Product Change Notification

Change Notification #: 112737 - 00
Change Title: Intel® Server System R1304GZ4GC
PCN 112737-00, Product Design
Update Rear Panel
Date of Publication: November 21, 2013

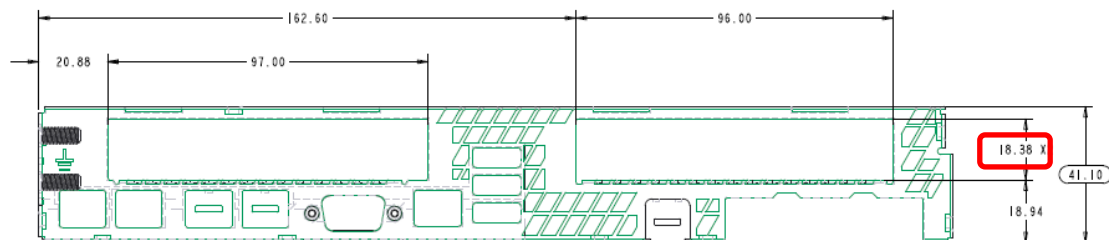
1. Update the system rear panel so that more PCIe devices and cable connectors (e.g. SFP+ PCIe card) can mechanically fit into the system. See the following pictures for details:

Pre-change:

Post-change:
